Subject: CLEARING ECCENTRIC SHAFT PLATE PROFILE MEMORY FROM PCM	Bulletin No: 01-010/08
	Last Issued: 8/25/2008

This bulletin supersedes the previous bulletin 01-030/05, issued on 11/22/2005 and 01-010/08 issued on 3/4/2008. The APPLICABLE MODEL(S) / VINS and REPAIR INFORMATION have been revised.

2004-2010 RX-8

OIL PRESSURE GAUGE NEEDLE WILL
MOVE TO RIGHT OF CENTER SLIGHTLY

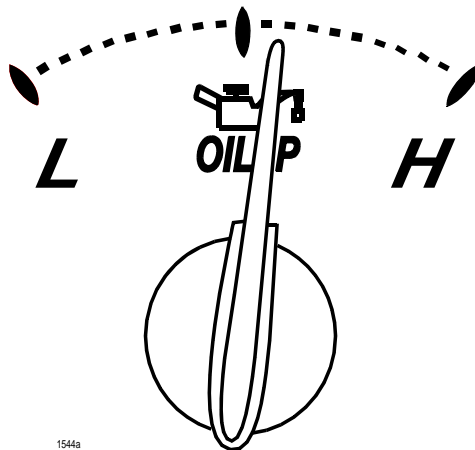
- Manual transmission equipped vehicles produced after VIN 40132647 and automatic transmission equipped vehicles produced after VIN 40132607 or vehicles with PCM updated to "L" calibration or later can confirm the clearing procedure was performed. If procedure was successful, the oil pressure gauge needle will move to right of center slightly (nearer H).
- Vehicles produced prior to these VIN's or vehicles without "L" calibration do not have an indicator to confirm the clearing procedure was performed.
